Errata Sheet

This **errata sheet** concerns errata items for the Series 500 (SDI-12) User’s Manual, dated February 2002.

Sensor Connections to 9-Pin or 25-Pin D-Shell RS-232 Serial Port

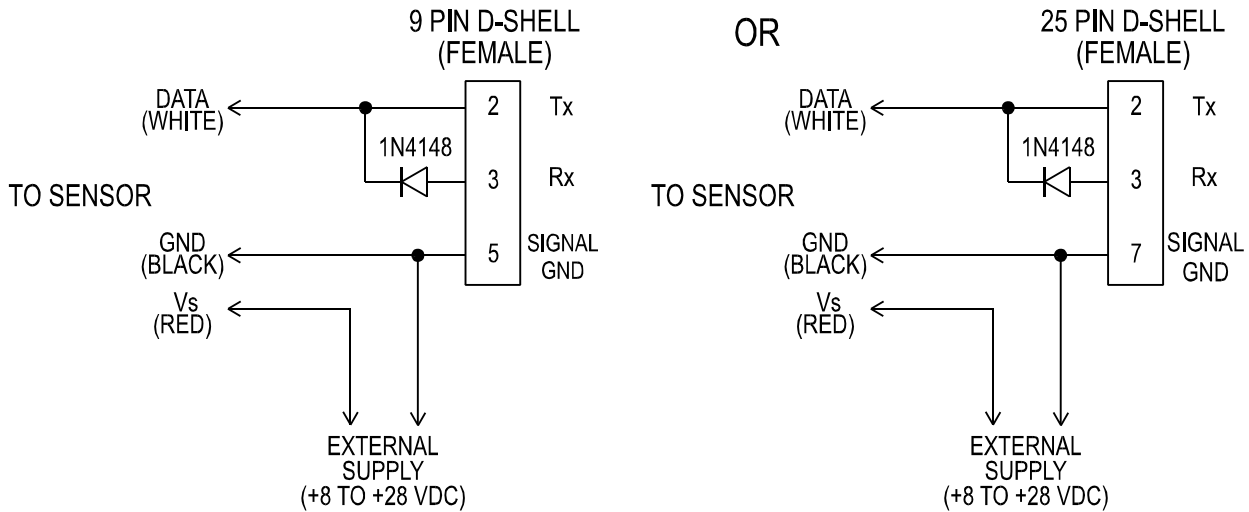
- Appendix page A-1: Third line; replace 24-pin with 25-pin...
- Appendix page A-2: Replace drawing with the following: (The 25 pin D-shell was erroneously labeled "24 pin.")
